195 District Park Pavilion
RFP I19561 - General Contracting Services
Addendum 005
June 26, 2024

Potential respondents to RFP #I19561, General Contracting Services for the 195 District Park Pavilion, should note the following:

195 District Park
Pavilion

BID SK-3.1 P1

1. Bid SK3.1 by Architecture Research Office

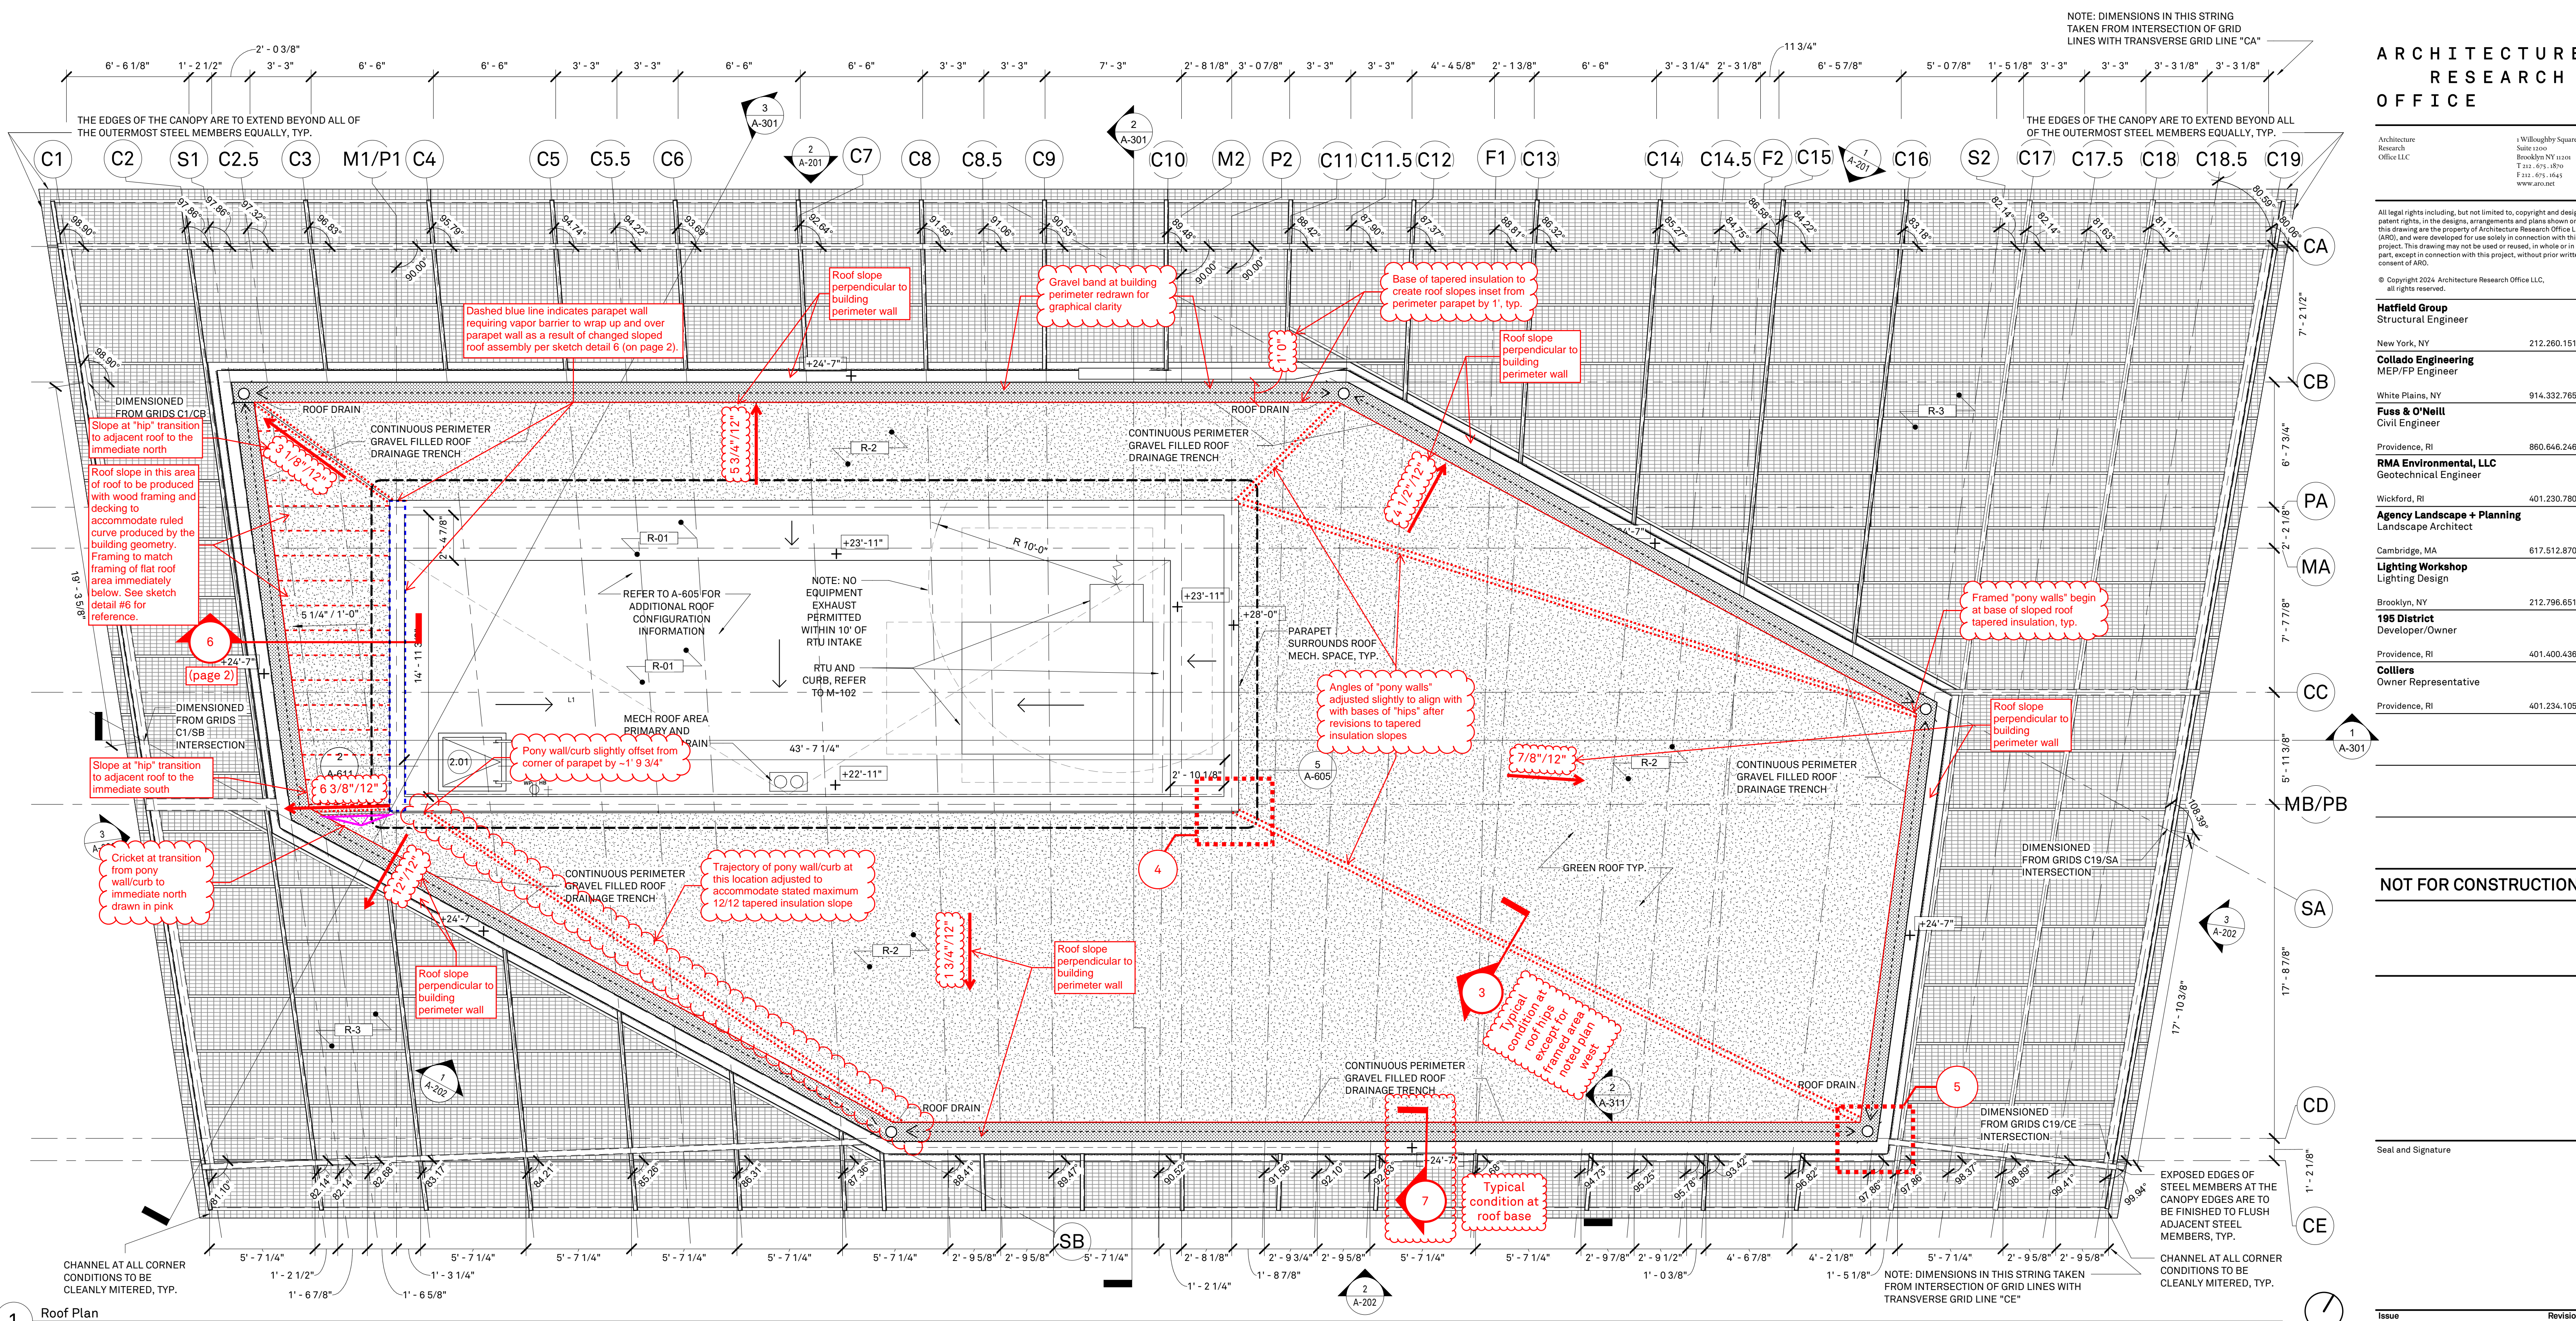
1. Proposals are now due on **Monday, June 1, 2024 at 2:00 PM**. All other submission requirements remain consistent with those in the RFP document.
2. The attached sketch, SK3.1, notes slight modifications to the roof pitch and clarifies several roof details. Proposers should incorporate these items into their pricing.

Roof type 1 assembly built-up to achieve roof slope

Green roof growth medium feathered to accommodate slope transitions at roof "hips", typ.

Roof type 2 assembly (see sketch detail #2 for reference). Built-in-place green roof assembly envelops pony wall assemblies, typ.

Roofing membrane laps over tops of pony walls, typ. Pony walls "capped" by second layer of roof membrane and heat welded to membranes of adjacent roofs to form tight corners.

Roof cover board. Cover board wraps pony walls, typ.

Vapor barrier as specified. Vapor barrier wraps pony walls, typ.

Framed and sheathed 2x4 "pony wall". Top of pony wall is proud of highest tapered insulation by +/-1"

Drawn roof slopes on roof plan are perpendicular to roof curb at base of roof, typ. UNO

Top of roof slope transition knee wall (see sketch detail #3 for reference). Knee wall assembly ties in to roof mechanical space parapet assembly. Top of knee wall +/- 3" below top of soil.

Line of perforated aluminum edge at base of planting medium separates planting medium from perimeter gravel course

Base of roof slope transition knee wall (see sketch detail #3 for reference), base of knee wall terminates at base of sloped green roof. Top of knee wall +/- 3" below top of soil.

"Flat" gravel perimeter drainage course. Slight slope toward roof drain leaders, typ.

Roof drain leader as specified. Gravel course surrounds roof drain leader, typ.
